Access Compliance Report

Public Rights-of-Way

(Curb Ramps)

Intersection ID: 18238	Main Street: QUEEN ANNE RD	Cross Street: S TRYON ST	Location: SE
ADA ID: C767E140FDBC	Ramp Type: Directional1	Initial Pass/Fail: Fail	Overall Compliance: No
Severity Score: 1.25			
Codes/Mitigation Info/Possible Solution		Field Measurements/Component Compliance

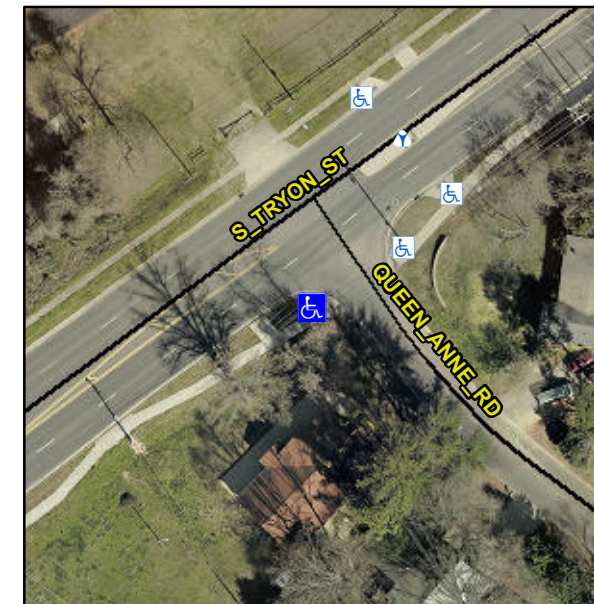
R304.5.3

Remove & Replace Entire Ramp.
